PLANNING APPLICATION REF. NO: 20/02973/EIAMAJ 21 & 38 ENGINEERS CLARO BARRACKS, CHATHAM ROAD, RIPON, NORTH YORKSHIRE HG4 2RD

RIPON BARRACKS

Planning Application Number 20/02973/EIAMAJ

A PRELIMINARY REVIEW OF THE TRANSPORT ASPECTS OF THE DEVELOPMENT PROPOSALS

- 2.2 The site and its relationship to Ripon is shown in Figure 2 “Existing Site” of the Transport Assessment. This Figure is reproduced below for reference.

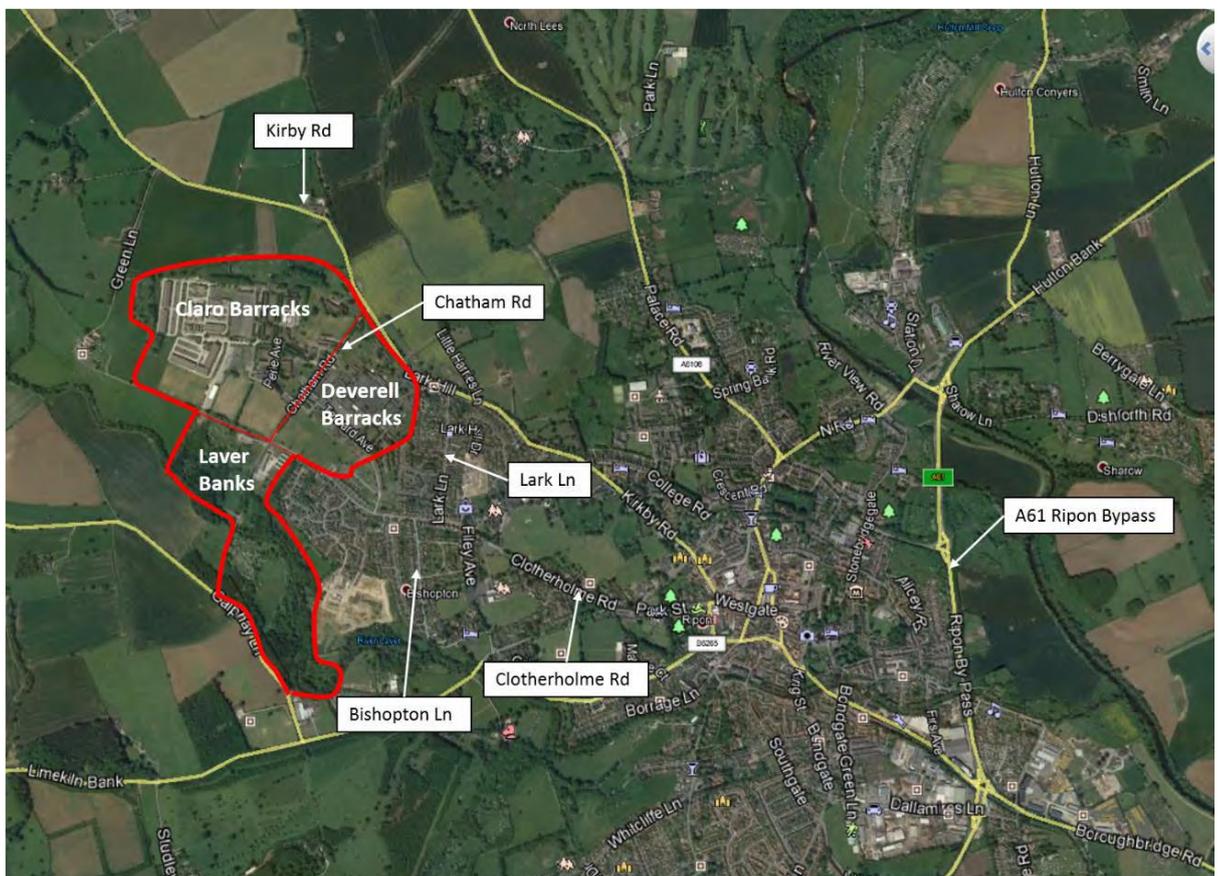
- 2.3 In our opinion the application site does not represent a “city centre periphery location” but rather an edge of town location.
- 2.4 The site’s location on the north-western edge of the city means that it will, inevitably, be difficult to encourage a significant proportion of those living and working at the barracks site to use sustainable modes of travel in preference to the private car.

- 2.5 As noted by the applicant in Section 5.3 of the Transport Assessment most of the city centre is beyond the 2 km maximum walking distance for commuting/school travel suggested by the Chartered Institute of Highways and Transportation (CIHT) (see Figure 26 of the Transport Assessment). Bus services serving the site are currently extremely limited.

- 2.14 We recommend that the applicant (i.e. the Secretary of State for Defence) significantly improves the sustainable transport aspects of the current scheme so that this site stands as an exemplar of the Government's approach to sustainable development rather than representing a "do minimum" option.
